主旨: [FI] S.16 Planning Application No. A/YL-KTN/1118 - Further Information

Proposed Temporary Warehouse (Excluding Dangerous Goods Godown) with Ancillary Facilities and Associated Filling of Land for a Period of 3 Years in "Agriculture" Zone, Various Lots in D.D. 107 and adjoining Government Land, Kam Tin, Yuen Long, New Territories

(S.16 Planning Application No. A/YL-KTN/1118)

Appendix I - Response to the Comments of Chief Engineer/Mainland North, Drainage Services Department (CE/MN, DSD)

Figure 1a. Drainage Layout (Con't)

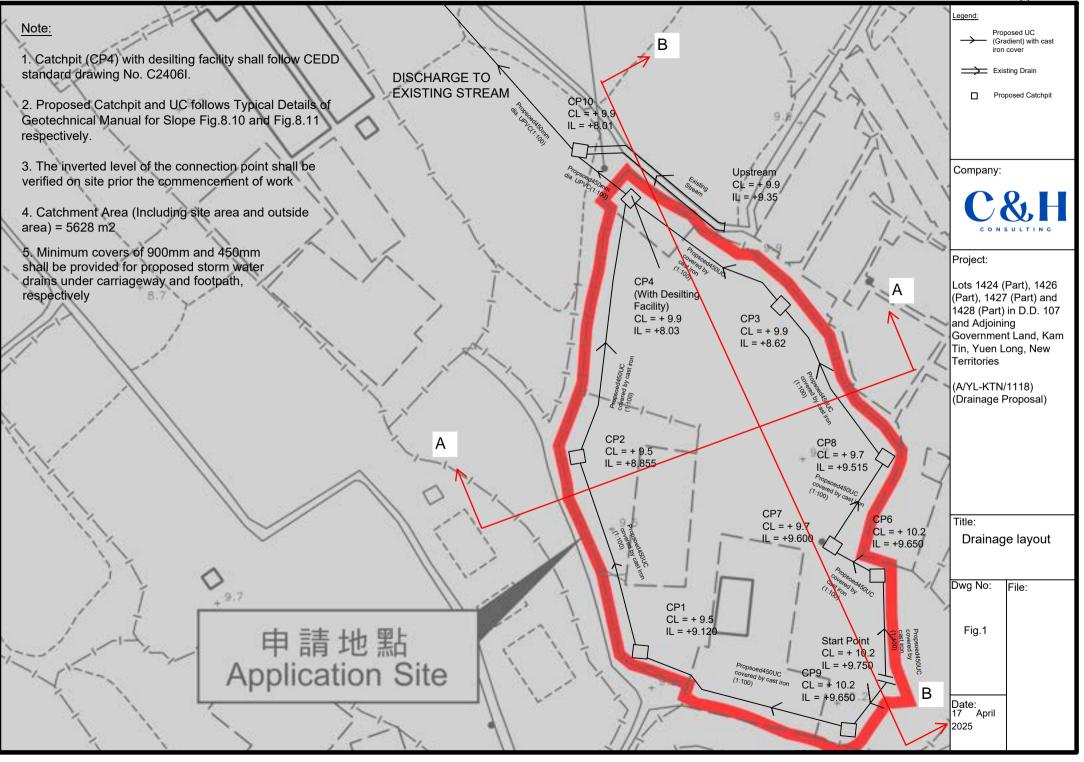
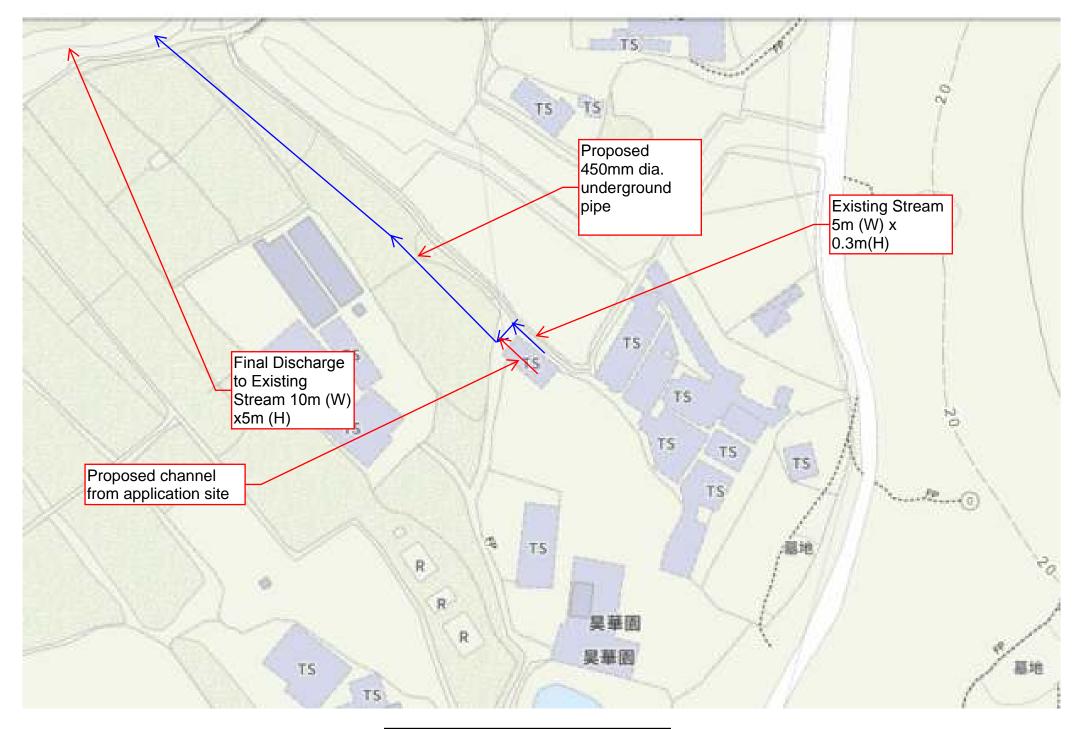
Comr	Comments of the CE/MN, DSD							
(Cont	(Contact Person: Ms. Jessica KWAN; Tel: 2300 1144)							
(1)	Figure 1 & 7: The applicant should clarify invert levels of existing streams at the upstream and downstream of the proposed catchpit CP10. Invert levels of the drainage facilities at the upstream shall be higher than that at the downstream;	Invert level of captioned drainage facilities has been provided in Fig.1 and Fig.7 (Appendix II).

(5)	The applicant shall note that minimum covers of 900mm and 450mm shall be provided for the proposed stormwater drains under carriageway and footpath respectively;	Noted and it is indicated in Fig.1 accordingly. (Appendix II).
(6)	The applicant should consult DLO/YL and seek consent from the relevant private lot owners for any drainage works to be carried out outside his lot boundary before commencement of the drainage works.	Noted.

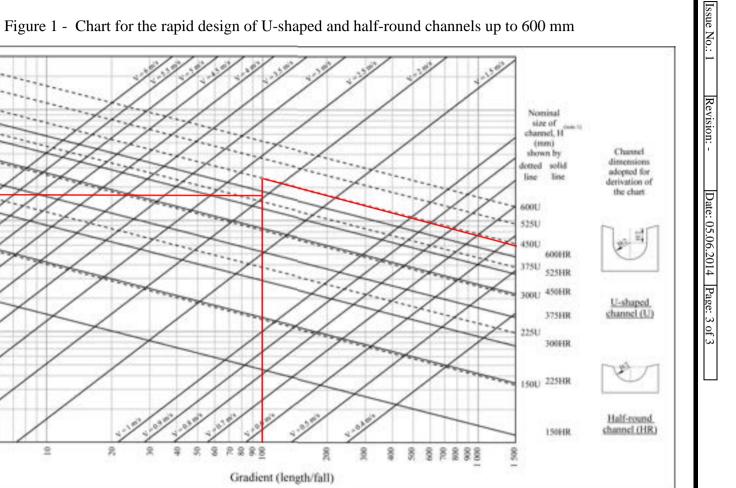
(3)	Figure 2: The external catchment area with concrete surface should be greater than that shown in the hydraulic calculation. The applicant should review runoff coefficient adopted in the hydraulic calculation;	External catchment area is reviewed and enlarged. Hydraulic calculation also is revised accordingly (Appendix II).

Catchment Area = 2683m² (Site Area), Catchment area = 2945m² (Outside area)

Surface runoff coefficient C = 0.95 (Site Area) and C = 0.54 (for outside catchment area)

Fig.7. Connection Detail

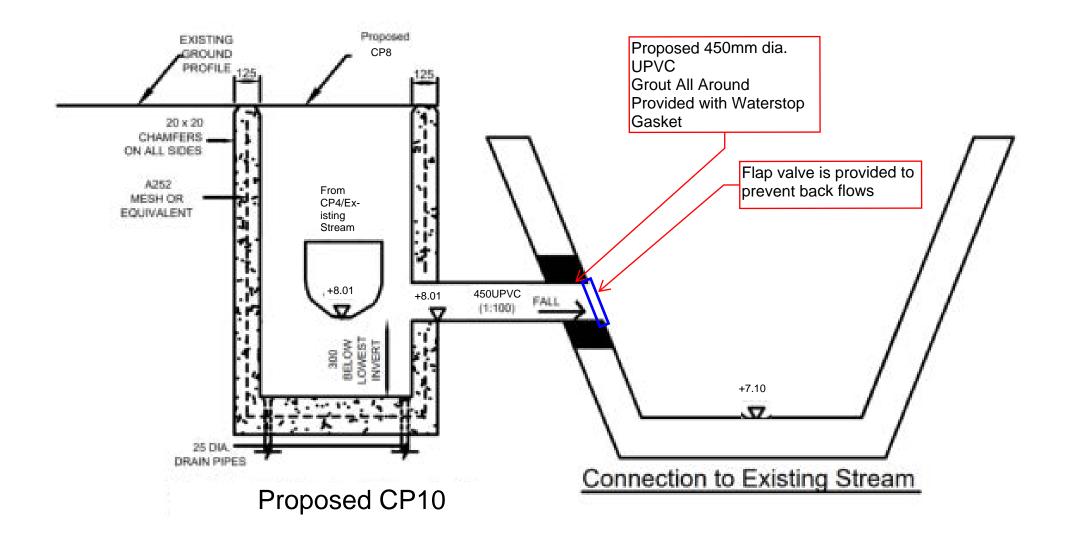
(2)	Connection to existing drainage facilities should be designed and constructed to prevent back flows at the drainage outlet when water level at the existing drainage facilities is high;	Flag valve is proposed, which is indicated in Fig.7 (Appendix II).

DRAWING NO. C2406 /2A

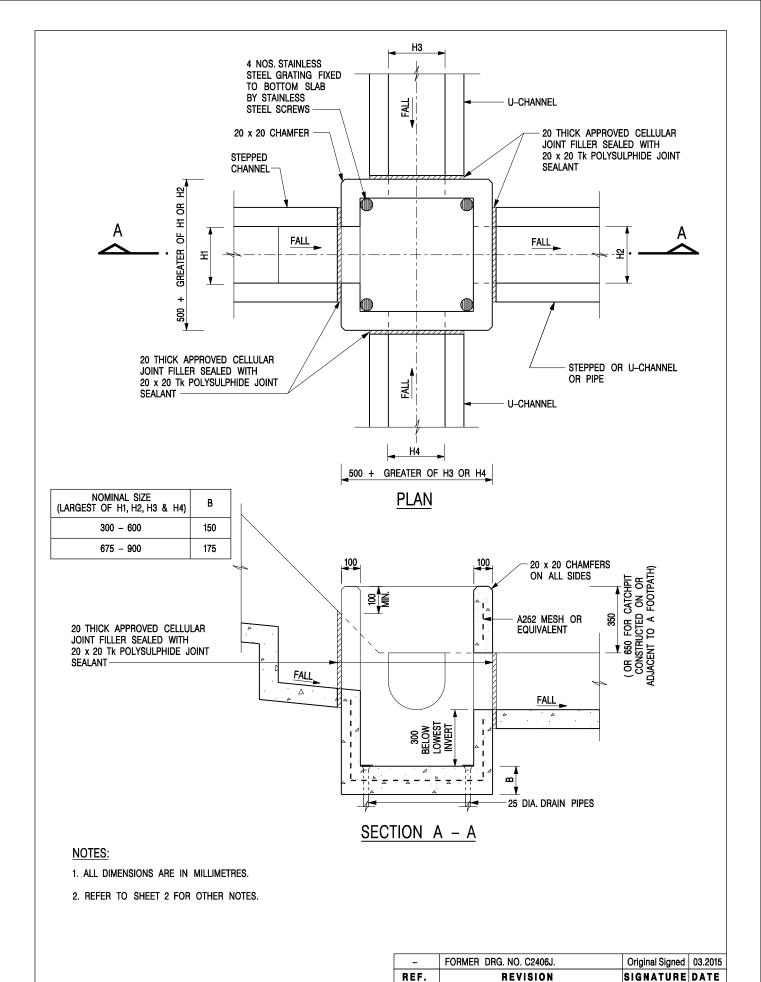
(4)	Drawing (No.: C2406/2) enclosed in the submitted proposal is not up-to-date;	The drawing is according to CEDD standard drawing, based on website: https://www.cedd.gov.hk/eng/publications/standards-spec-handbooks-cost/standards-spec-handbooks-cost/standards-spec-handbooks-cost/standards-spec-handbooks-cost/standards-spec-handbooks-cost/standards-spec-handbooks-cost/standards-spec-handbooks-cost/standards-spec-handbooks-cost/standards-spec-handbooks-cost/standards-spec-spec-handbooks-cost/standards-spec-spec-handbooks-cost/standards-spec-spec-handbooks-cost/standards-spec-spec-handbooks-cost/standards-spec-spec-handbooks-cost/standards-spec-spec-handbooks-cost/standards-spec-spec-spec-spec-spec-spec-spec-spe
